Please find enclosed the response to comments on the Final Project Closeout Report for Building 371, DWF-101-05, a Type 3 Facility. Also enclosed is Revision 1 to the Final Decommissioning Closeout Report for the Building 371/374 Closure Project. This response to comment incorporates new text to the document, which required the entire document to be revised. For completeness, Revision 1 is a stand alone document which has reproduced the original document in black and white and new additions in color.

TRANSMITTAL OF REVISION 1 OF DECOMMISSIONING CLOSEOUT REPORT FOR THE 371/374 CLOSURE PROJECT AND RESPONSE TO COLORADO DEPARTMENT OF PUBLIC HEALTH AND ENVIRONMENT (CDPHE) COMMENTS -- DWF-106-05

SUMMARY OF B371 CLOSEOUT REPORT RESPONSE TO COMMENTS TO COPHE

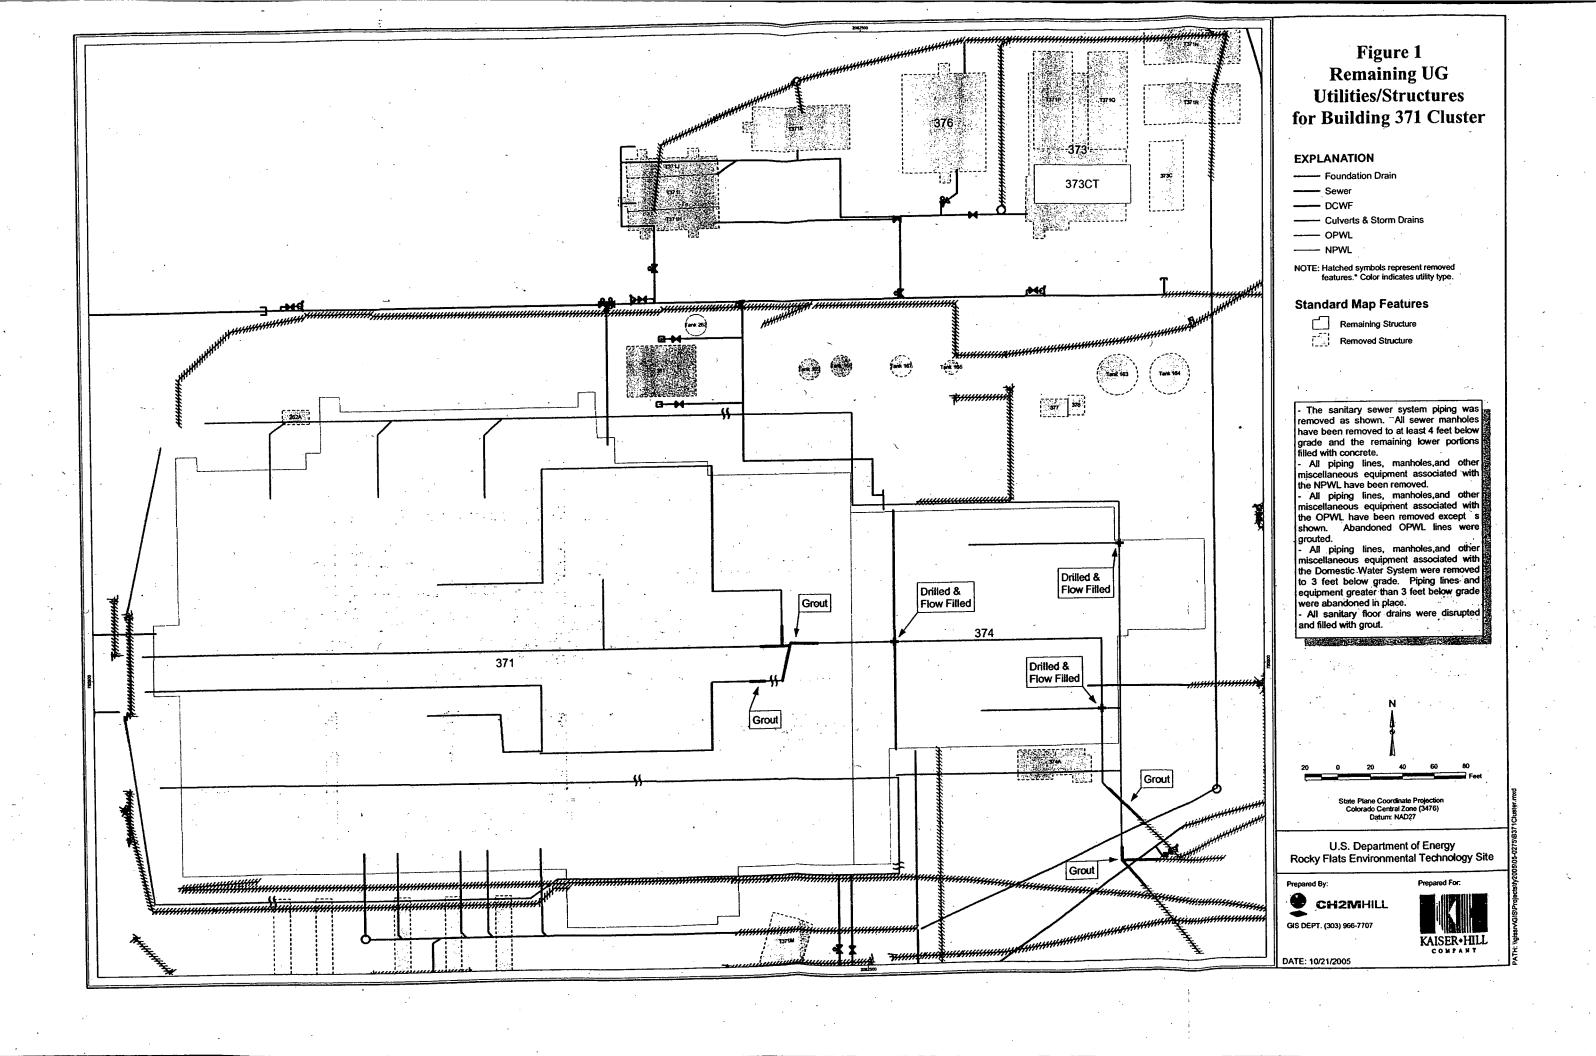
1) Figure 1 – This figure is difficult to understand. Please provide an explanation as to which structures are actually associated with this Closeout Report and which are just being shown because they are in this area. We previously asked that a figure be provided that showed all facilities referenced in Table 1-1. However, this figure does not show the location of CT911, T371G, T371S, T376A, or Tanks 224, 225, 226, 227, 228, T-802 to T-805, or W-803. Nor does it show the location of other facilities discussed in this report, such as Tanks 165 and 170. However it does show the location of Trailers T371I, P, Q, N, R, C and M, which are not mentioned, but were taken down during this demolition activity. As such, these should also be included unless they are provided in separate closeout reports (in which case they need to be distinguished on this figure from the facilities actually included in this closeout report). Please provide this figure in color since it is not possible to identify the various lines shown in the Explanation. Also, what is the line going through B374 (N to S)? It looks to be a water line, yet it is identified to be drilled and filled? Why would there be a water line going under B374? It should have gone through the building and been removed. Please modify as appropriate.

2) Figure 1 – This figure is supposed to show the remaining and removed structures. However, it is our understanding that due to the many demolition evolutions performed over time that not all of B371/374 remains as shown. As such, it is our understanding that the East Dock Room 3813 was removed or partly removed, as well as at least part of Dock 5 (CR dated 3/8/05). Also, 373CT is shown as remaining, yet the Cooling Tower was removed. Please show the proper location/extent for B373, which is described in Sec 1.1.4 as consisting of a cooling tower and pump house/vault.

3) Figure 1 – the information provided regarding the foundation and storm drains does not appear to provide accurate or complete information. As such it is recommended to provide the actual engineering drawings utilized, showing the disruption/grouting locations. Also, the CR dated June 28, 2005 identifies the actions that were performed.

Figure 1 and Figure 2 are basically the same except that Figure 1 provides the zoomed in view of B371/374 to depict the way the foundation drains were dealt with, and not to lose resolution for the other lines. Figure 2 provides a full cluster depiction of the remaining lines and facilities. The N/S water line in B374 has been removed.

B373 and associated pumps were removed during building demolition (along with CT911, aka B373C); only the below ground pumphouse/pump vault for 373CT remains. New drawings show that Docks 5, and 3813 were both completely removed during the final phases of building demolition.

Figure 1 has been updated to reflect the changes as identified..

FLOOR DIAGRAMS OF DISMANTLEMENT SETS

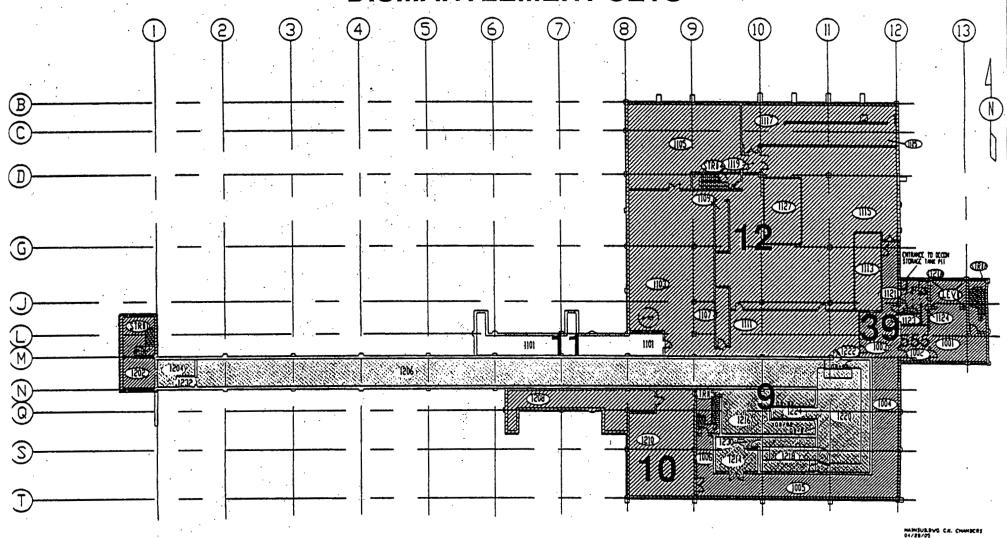
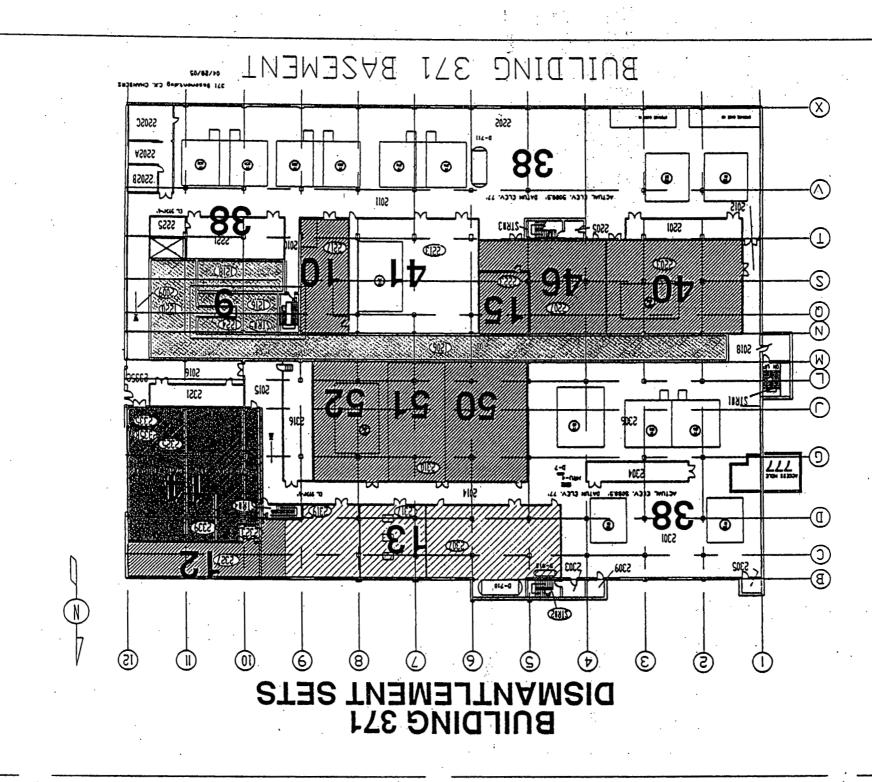
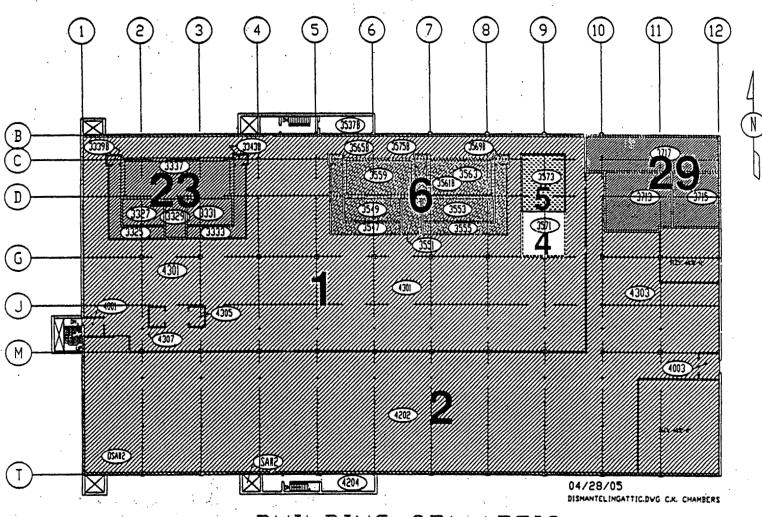
7) Attachment C – The figure provided for B374 does not identify the actual dismantlement sets as do the figures for B371. The figure provided for B374 is actually showing the rad survey units, with some of the sets written in for the groundfloor only. Please provide an appropriate figure for B374 identifying the extent of the sets for B374.

The sets for B374 included 18, 19, 56, 57, & 58. The drawing was hand delivered.

CONTOUR DRAWING OF FINAL GRADE

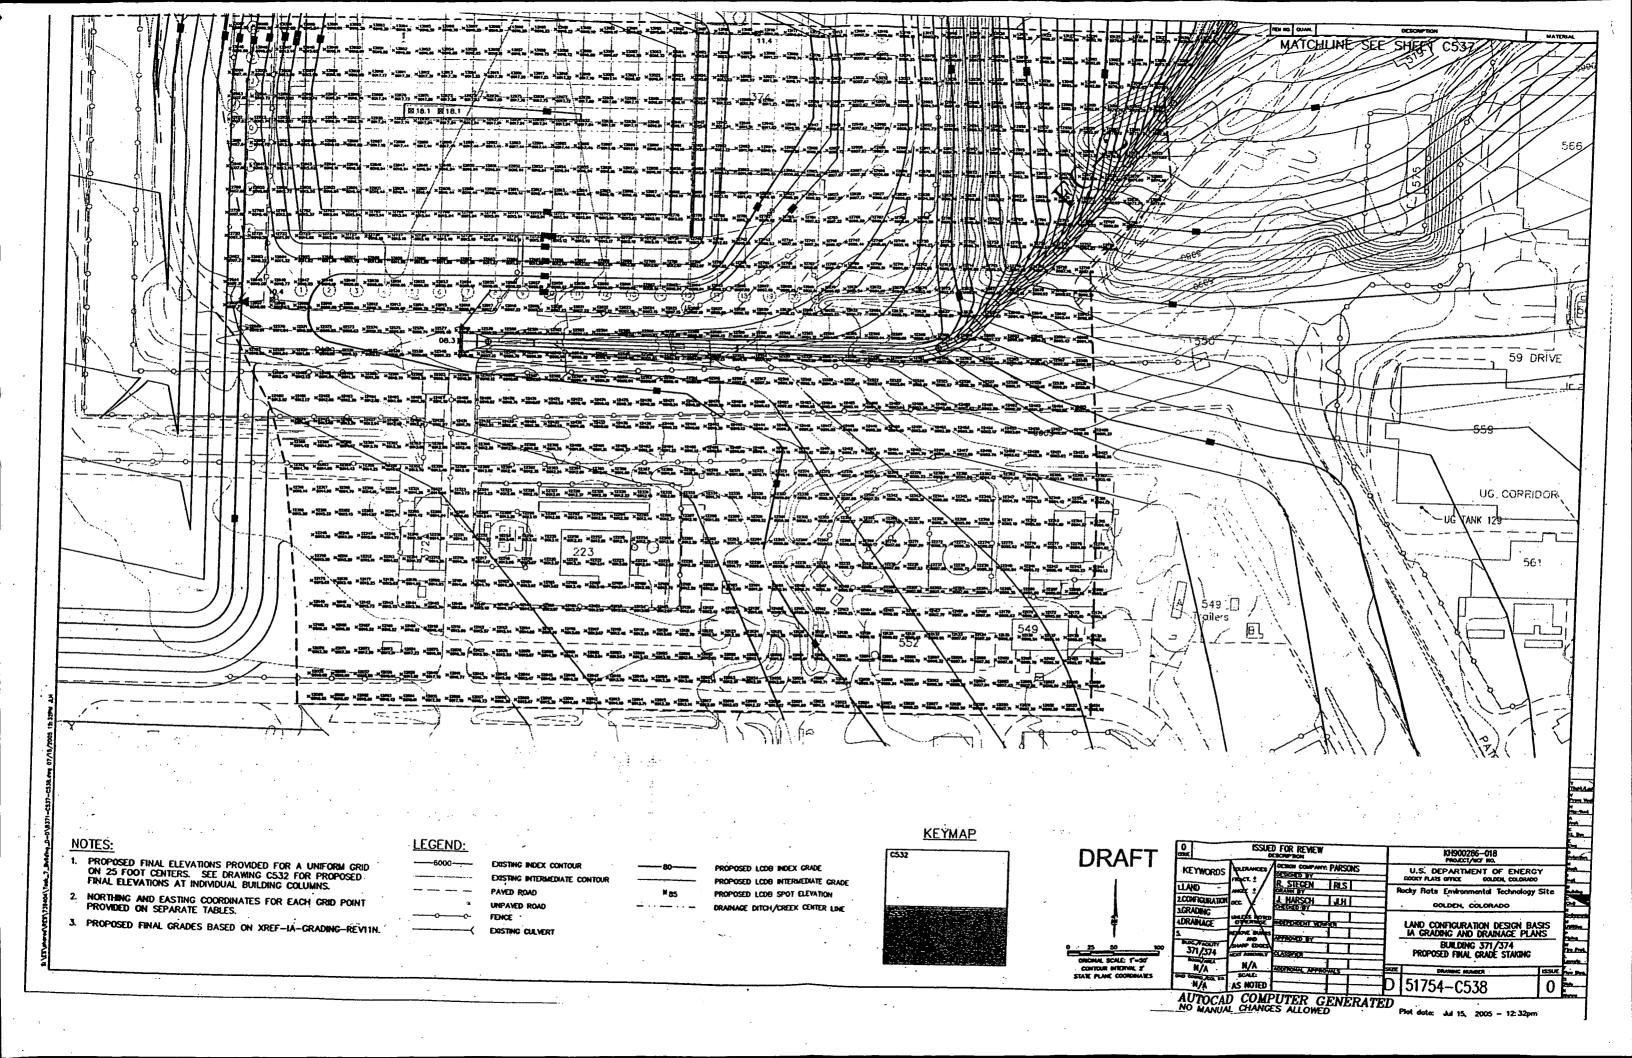
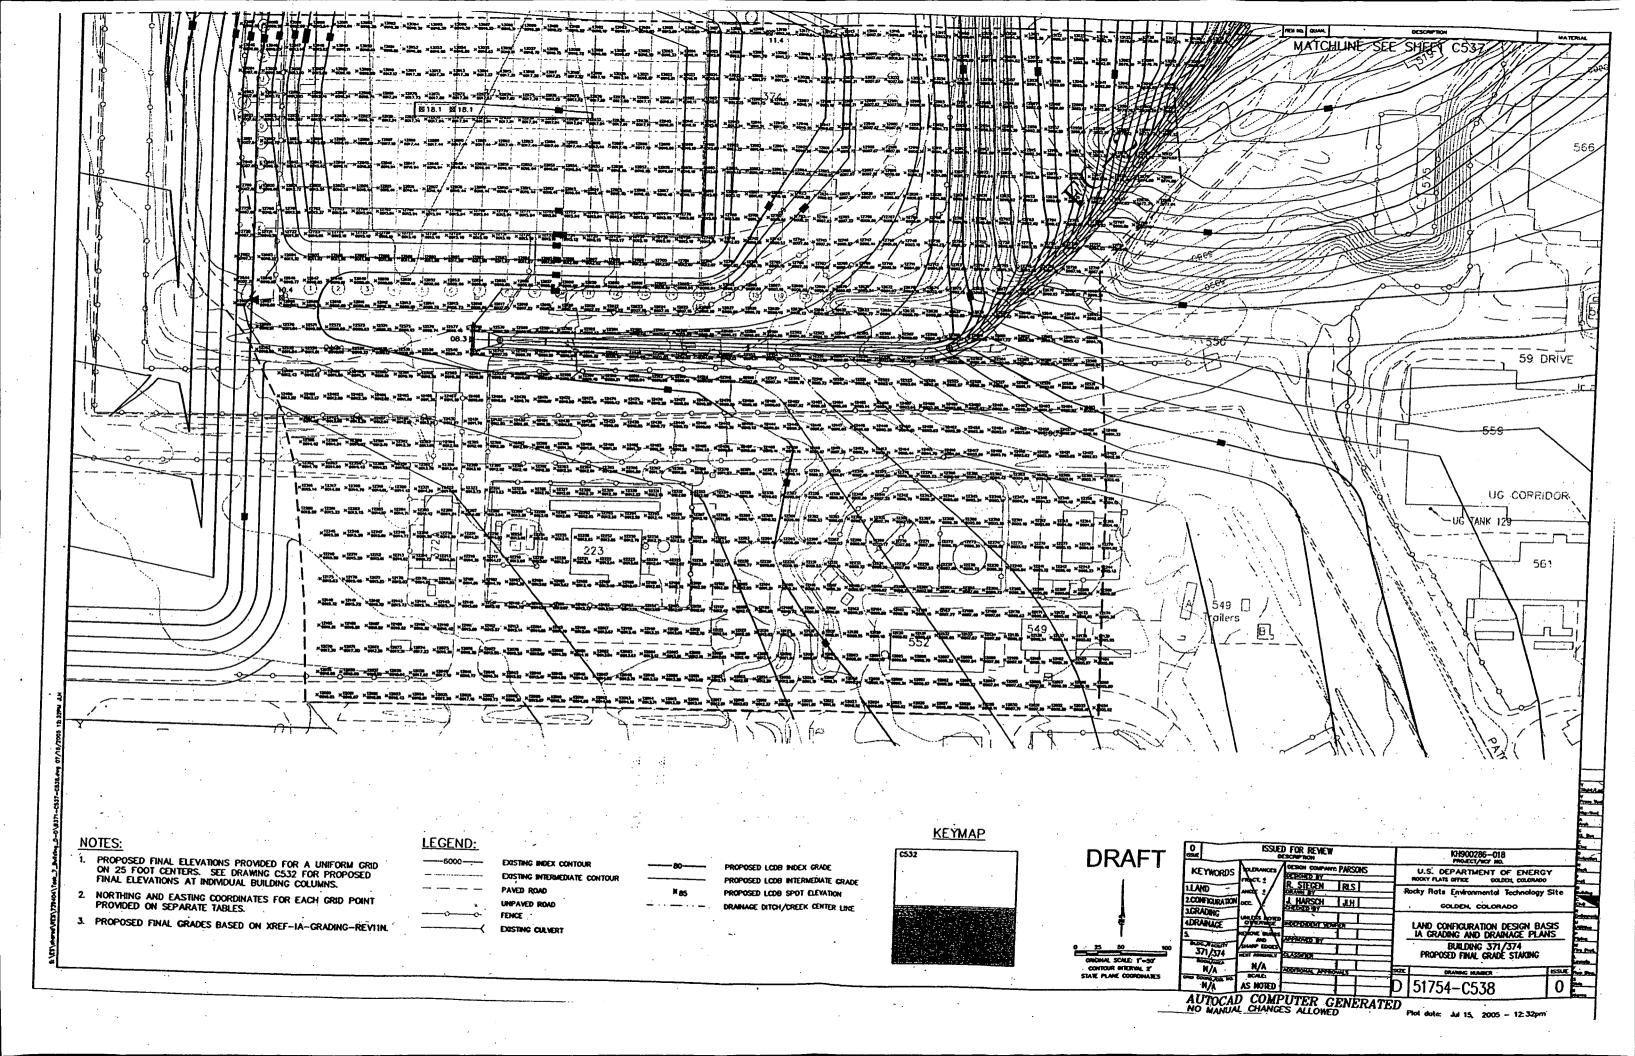
16) Attachment F – Please provide the second figure showing the contouring to the north of 371/374. We have two figures # 51754-C538, and need the figure to the north.

Figure # 51754-C537 (North grade) was hand delivered.
